APPLICATION NO.	FILING DATE	FIRST NAMED INVENTOR	ATTORNEY DOCKET NO.	CONFIRMATION NO.
10/720,821	11/24/2003	Douglas B. Wilson	114089.120	5355
23483	7590	01/13/2006	EXAMINER	
WILMER CUTLER PICKERING HALE AND DORR LLP 60 STATE STREET BOSTON, MA 02109			LUONG, VINH	
			ART UNIT	PAPER NUMBER
			3682	
DATE MAILED: 01/13/2006

Office Action Summary	Application No.	Applicant(s)	
	10/720,821	WILSON, DOUGLAS B.	
	Examiner	Art Unit	
	Vinh T. Luong	3682

ATTACHMENT 1

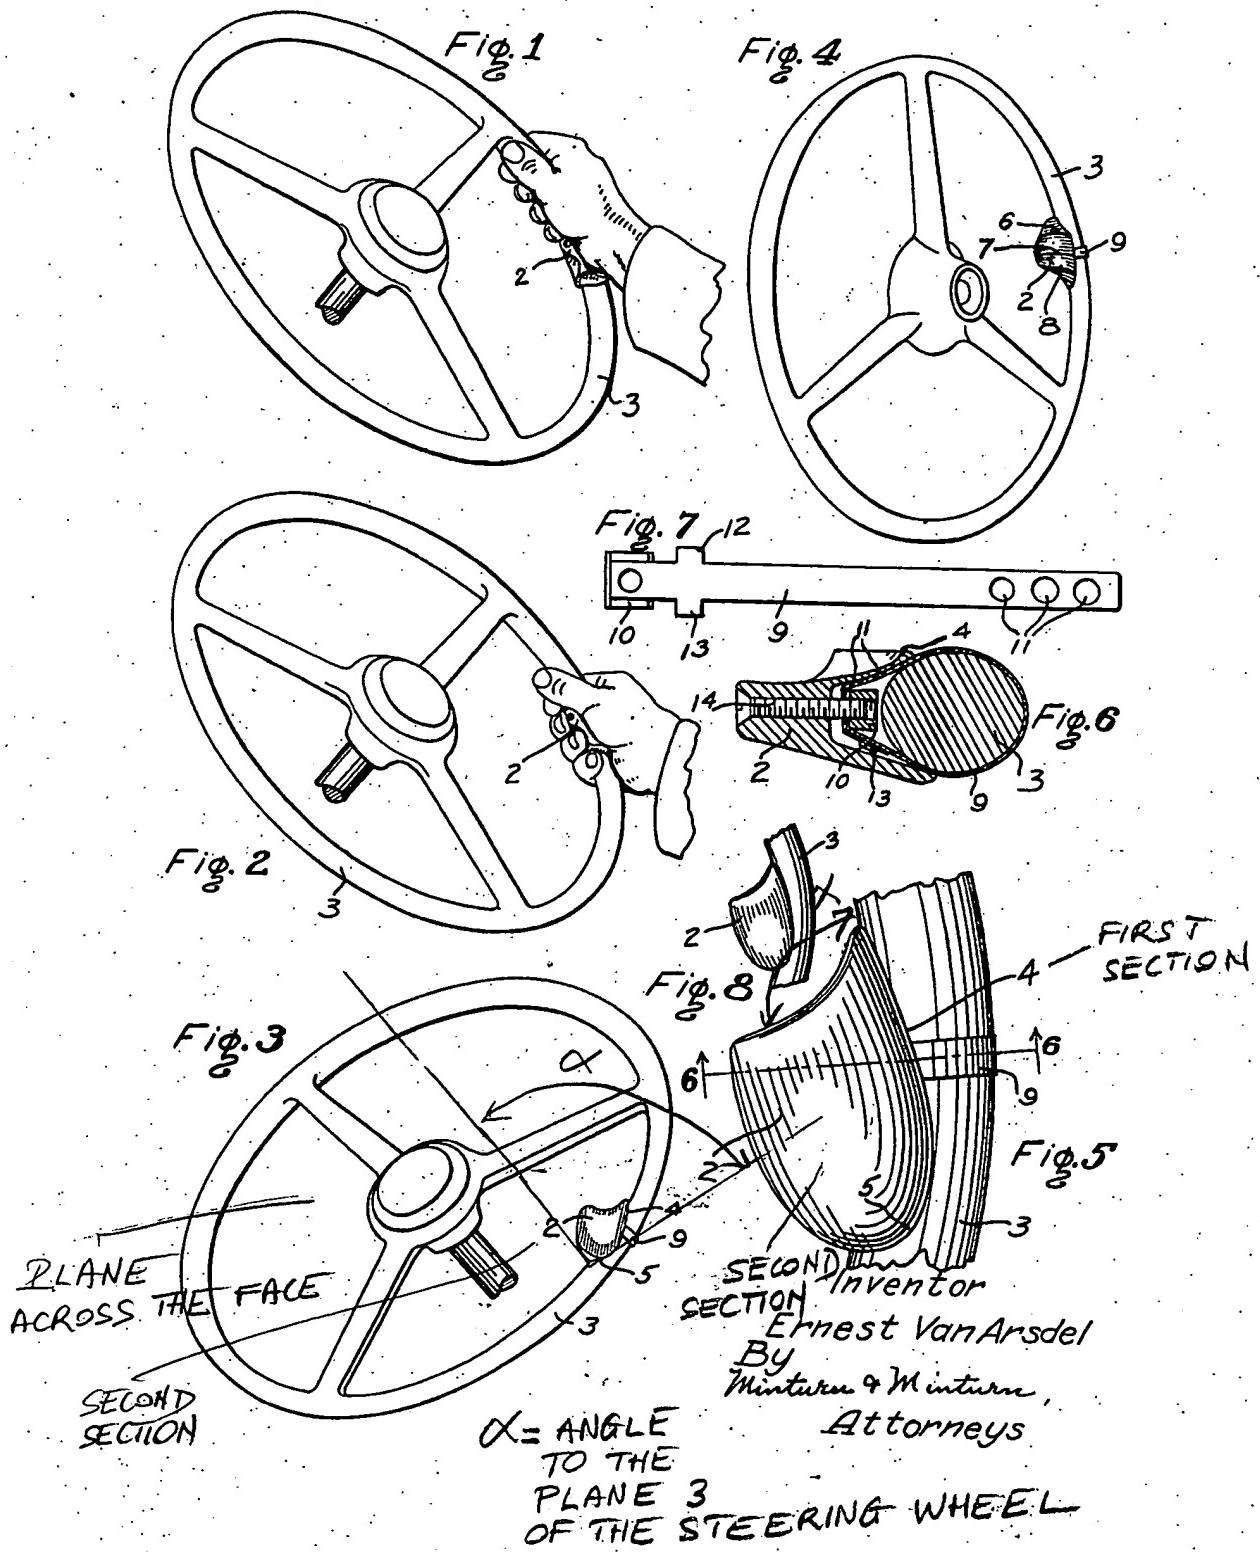
Regarding claim 20, Van Arsdel teaches a fatigue relieving/preventing apparatus associated with a steering wheel 3 for controlling a vehicle comprising:

a first section 4 (i.e., horizontal section in Fig. 3) that connects to a peripheral portion 3 of the steering wheel 3; and

a second section 2 (i.e., upward section in Figs. 3 and 5) that connects to and extends from the first section 4 at the peripheral portion 3 of the steering wheel 3, the second section 2 extends from the first section 4 outward at an angle (see angle α in Figs. 3 and 5 of the Attachment 1) to a plane (Att. 1) across a face to the steering wheel 3, with the second section 2 inherently for supporting at least a portion of a vehicular operator's body (e.g., the hand as seen

in Figs. 1 and 2) when pressure from the portion of the vehicular operator's body on the second section 2 is less than the pressure for deforming the second section 2 out of interference with the vehicular operator's ability to operate the steering wheel 3, and deforming out of interference with the vehicular operator's ability to operate the steering wheel when pressure from the portion of the vehicular operator's body on the second section is equal to or greater than the pressure for deforming the second section out of interference with the vehicular operator's ability to operate the steering wheel 3. *Ibid.*, right column on page 1, lines 29-54.

ATTACHMENT 2

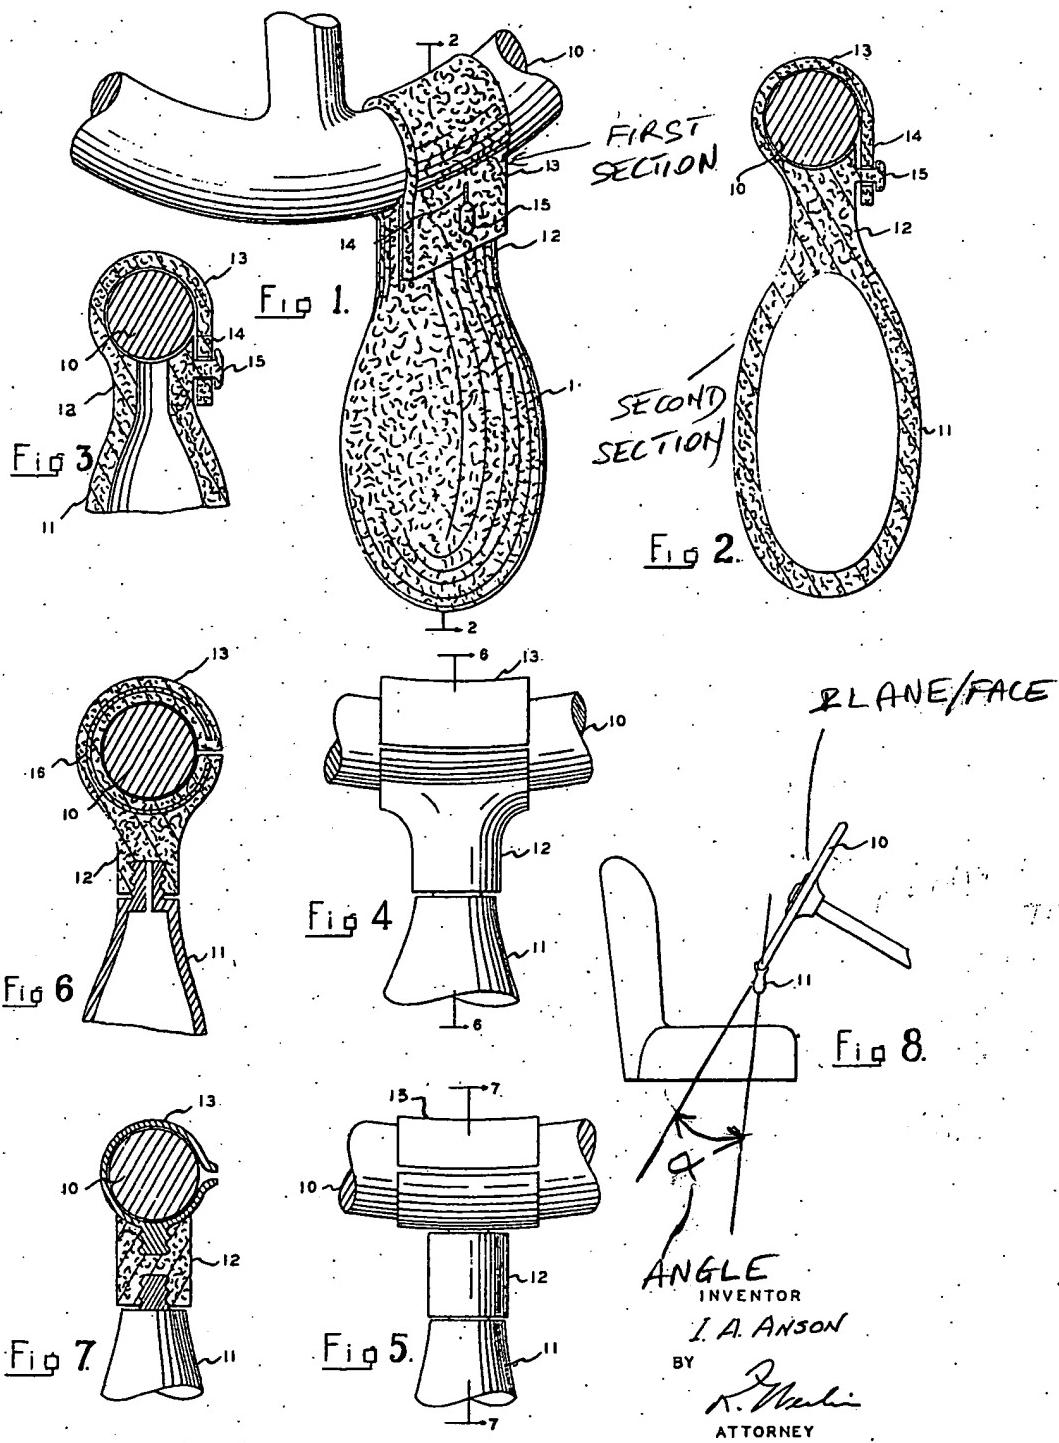
Regarding claim 20, Anson teaches a fatigue relieving/preventing apparatus associated with a steering wheel 10 for controlling a vehicle comprising:

a first section 13 that connects to a peripheral portion of the steering wheel 10;
style="padding-left: 40px;">a second section 11 extends from the first section at the peripheral portion of the steering wheel 10, the second section 11 extends from the first section 13 outward at an angle (see angle α in Fig. 8 of Attachment 2) to a plane (Att. 2) across a face (Att. 2) to the steering wheel 3, the second section 11 inherently for supporting at least a portion of a vehicular operator's body (e.g., the hand) when pressure from the portion of the vehicular operator's body on the second section 11 is less than the pressure for deforming the second section 11 out of interference with the vehicular operator's ability to operate the steering wheel 10, and deforming out of interference with the vehicular operator's ability to operate the steering wheel 10 when pressure from the portion of the vehicular operator's body on the second section 11 is equal to or greater than the pressure for deforming the second section 11 out of interference with the vehicular operator's ability to operate the steering wheel 10.

ATTACHMENT 3

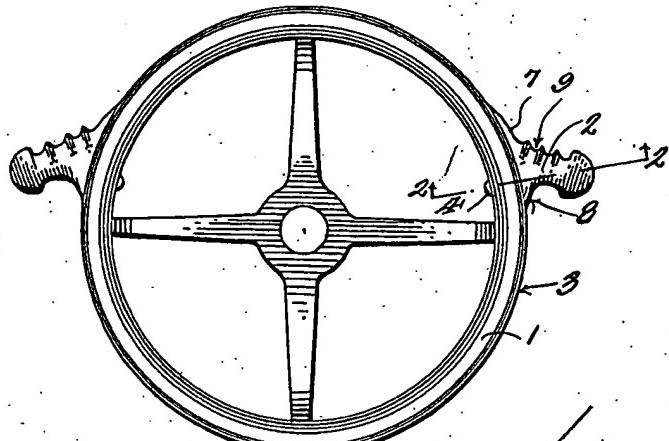
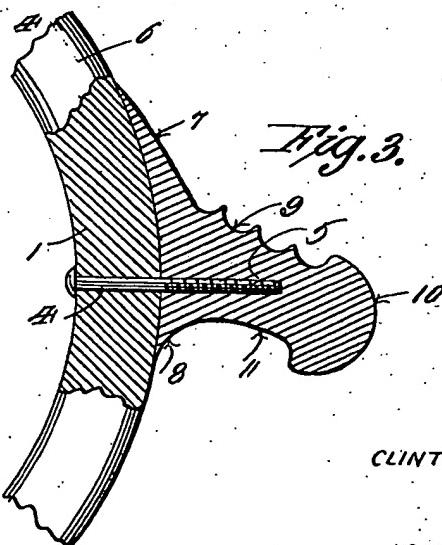
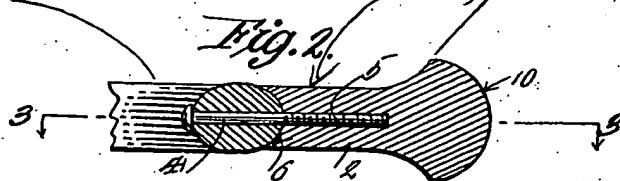
Regarding claim 20, Laubach teaches a fatigue relieving/preventing apparatus associated with a steering wheel 1 for controlling a vehicle comprising:

a first section 7, 8 that connects to a peripheral portion of the steering wheel 1;
a second section 10 that connects to, and extends from, the first section 7, 8 at the peripheral portion of the steering wheel 1, the second section 10 extends from the first section 7, 8 outward at an angle (see angle α in Fig. 2 of the Attachment 3) to a plane (Att. 3) across a face

(Att. 3) to the steering wheel 1, the second section 10 inherently for supporting at least a portion of a vehicular operator's body (e.g., the hand) when pressure from the portion of the vehicular operator's body on the second section 10 is less than the pressure for deforming the second section 10 out of interference with the vehicular operator's ability to operate the steering wheel 1, and deforming out of interference with the vehicular operator's ability to operate the steering wheel 1 when pressure from the portion of the vehicular operator's body on the second section 10 is equal to or greater than the pressure for deforming the second section 10 out of interference with the vehicular operator's ability to operate the steering wheel 1.

Regarding claim 27, the second section 10 includes at least two second sections 10 that each connect to the first section 7, 8 at separate locations (by comparing Applicant's Fig. 2 with Laubach's Fig. 1).
